SUNDRY NOTICES AND REPORTS ON WELLS (DO NOT USE THIS FORM FOR PROPOSALS TO DRILL OR TO DEEPEN OR PLUG BACK TO A DIFFERENT RESERVOIR. USE "APPLICATION FOR PERMIT" (FORM C-101) FOR SUCH PROPOSALS.)		WELL API NO. 30-025-51527

Devon Energy Production Company L.P. respectfully requests the following changes to the approved APD:

BOA STATE COM 708H

Operator: DEVON ENERGY PRODUCTION COMPANY, LP 333 West Sheridan Ave. Oklahoma City, OK 73102	OGRID: 6137
	Action Number: 342704
	Action Type: [C-103] NOI Change of Plans (C-103A)

BOP Break Test Variance – Intermediate Casing

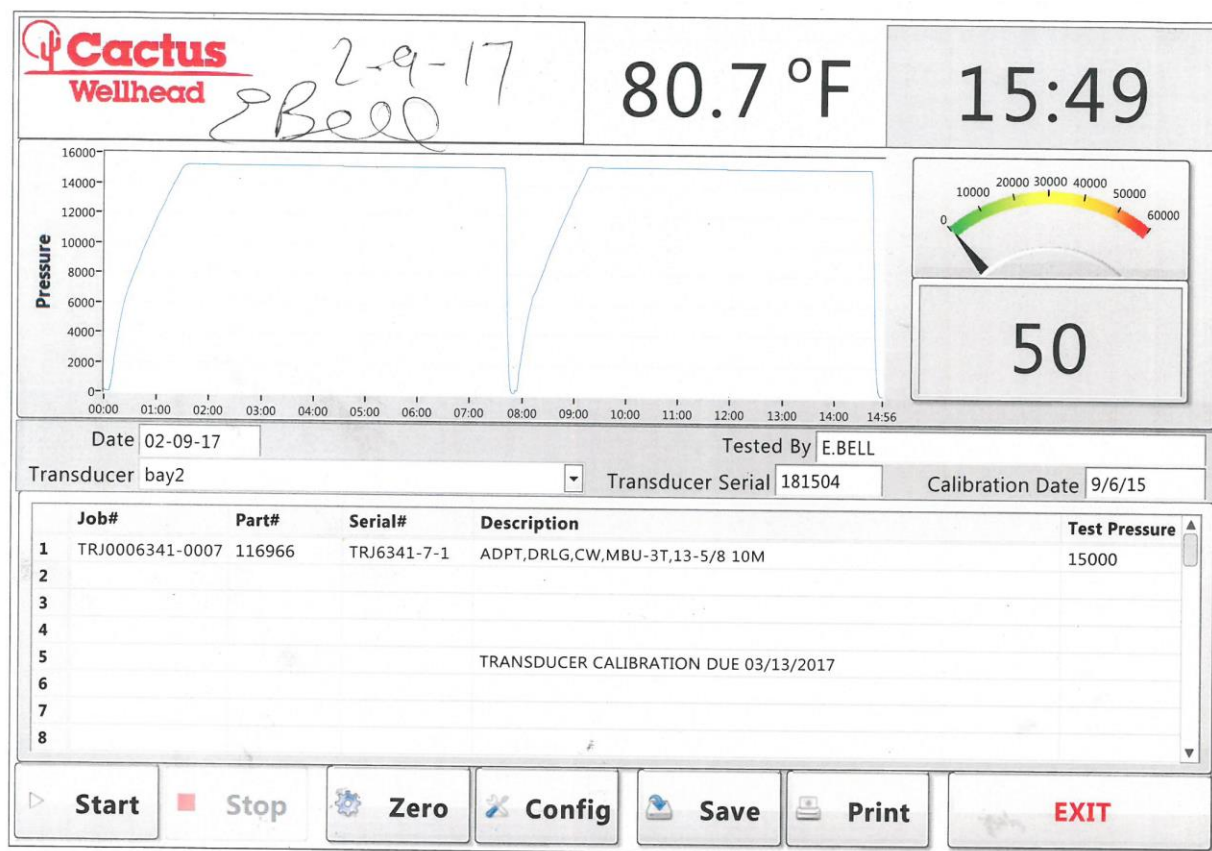
Devon Energy requests to only test BOP connection breaks after drilling out of surface casing and while skidding between wells which conforms to API Standard 53 and industry standards. This test will include the Top Pipe Rams, HCR, Kill Line Check Valve, QDC (quick disconnect to wellhead) and Shell of BOP to 5M for 10 minutes. If a break to the flex hose that runs to the choke manifold is required due to repositioning from a skid, the HCR will remain open during the shell test to include that additional break. The variance only pertains to intermediate hole-sections and no deeper than the Bone Springs Formation where 5M BOP tests are required. The initial BOP test will follow OOGO2.III.A.2.i, and subsequent tests following a skid will only test connections that are broken. The annular preventer will be tested to 100% working pressure. This variance will meet or exceed OOGO2.III.A.2.i per the following: Devon Energy will perform a full BOP test per OOGO2.III.A.2.i before drilling out of the intermediate casing string(s) and starting the production hole, before starting any hole section that requires a 10M test, or before the expiration of the allotted 14-days for 5M intermediate batch drilling, whichever is sooner. We will utilize a 200' TVD tolerance between intermediate shoes as the cutoff for a full BOP test. The BLM will be contacted 4hrs prior to a BOPE test. The BLM will be notified if and when a well control event is encountered.

1. Primary barrier remains fluid
2. In the event of an influx due to being underbalanced and after a realized gain or flow, the order of closing BOPE is as follows:
 1. Annular first
 2. If annular were to not hold, Upper pipe rams second (which were tested on the skid BOP test)
 3. If the Upper Pipe Rams were to not hold, Lower Pipe Rams would be third
